RE: **Addendum No. 1**, to RFP0218335036 DHS IMHI Witte Building Water Main Replacement

**PROJECT NAME: DHSIMHI WITTE BUILDING WATER MAIN REPLACEMENT**

**PROJECT #: DAS #8978.00**

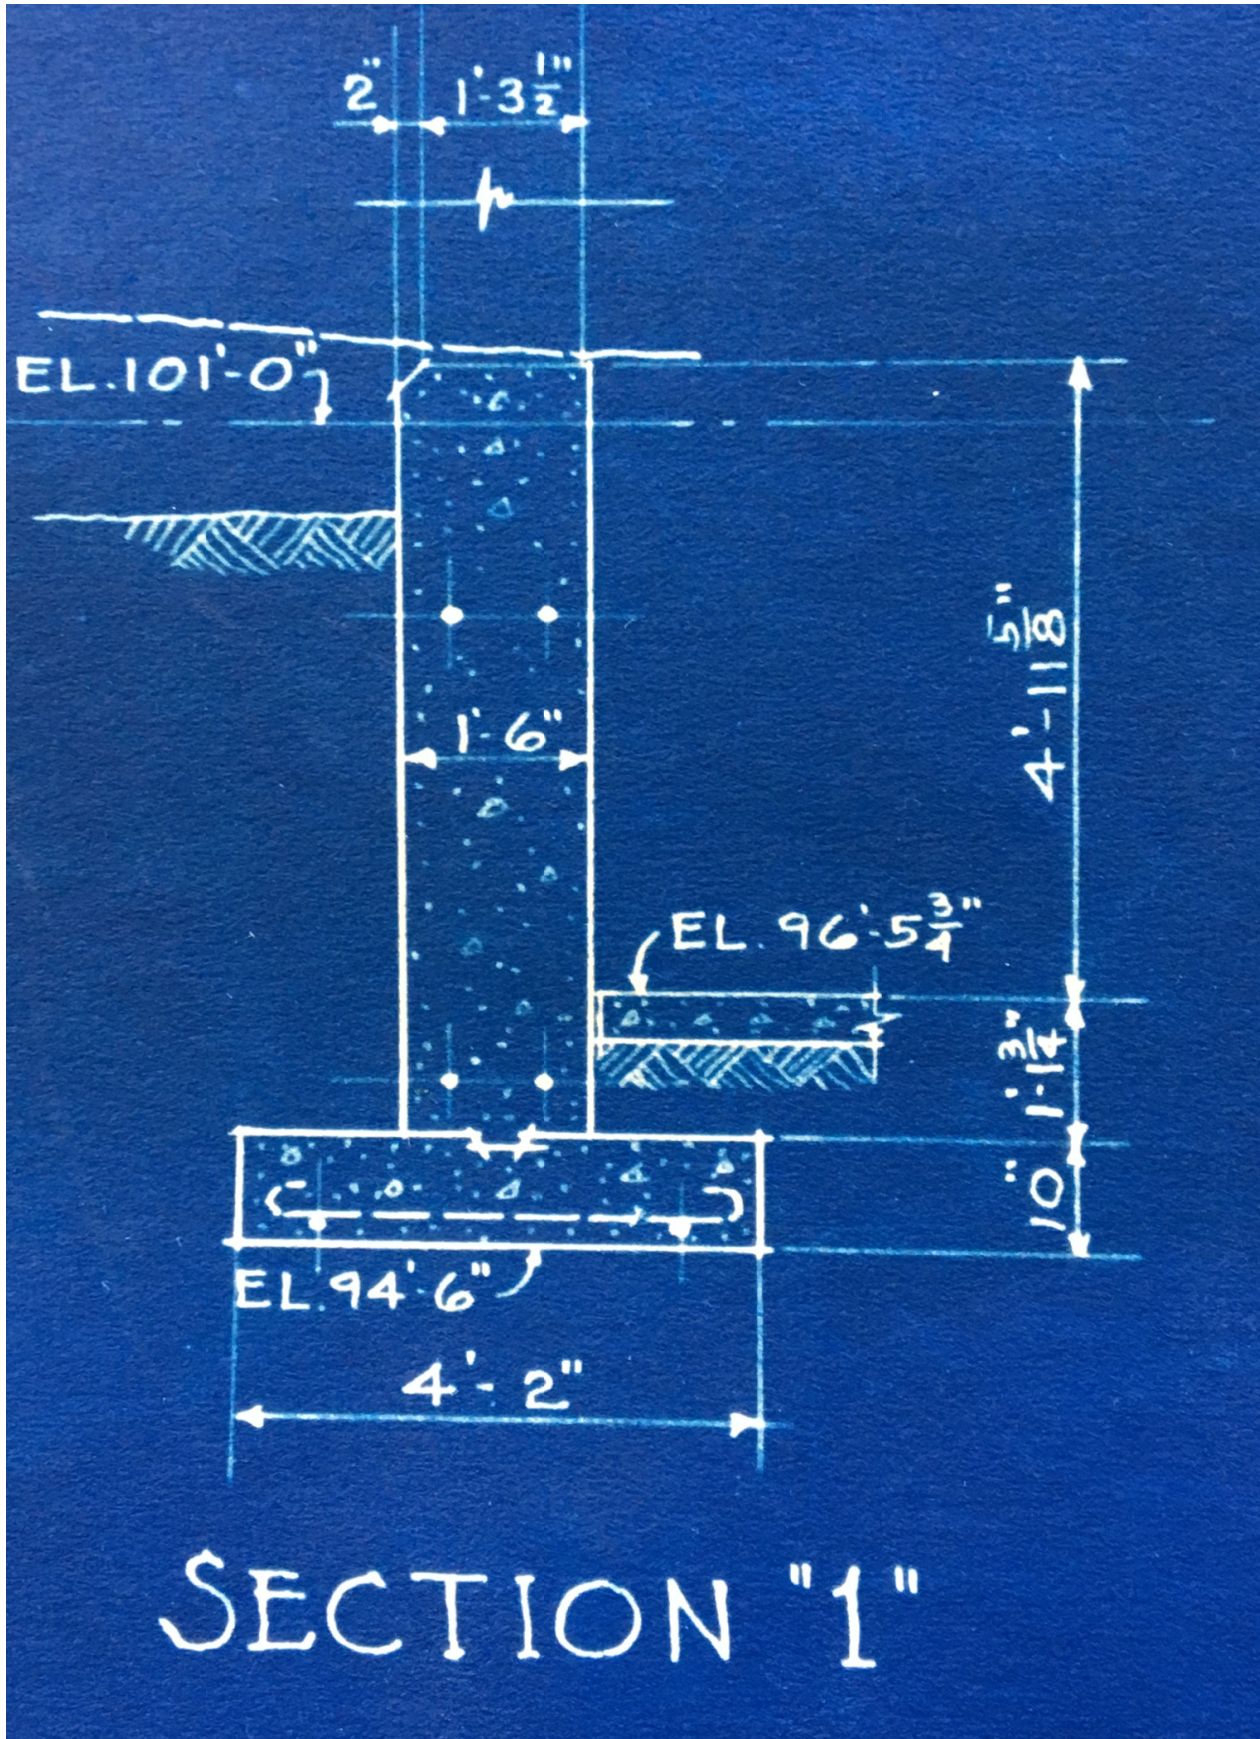
Existing 6" valve for Building Main Needs to be capped

Proposed location of proposed new 6" water main. Approximately 235 lineal feet

Proposed location of New Hydrant

Existing 12" City Water Main

Existing Water Main

Existing Building Footing
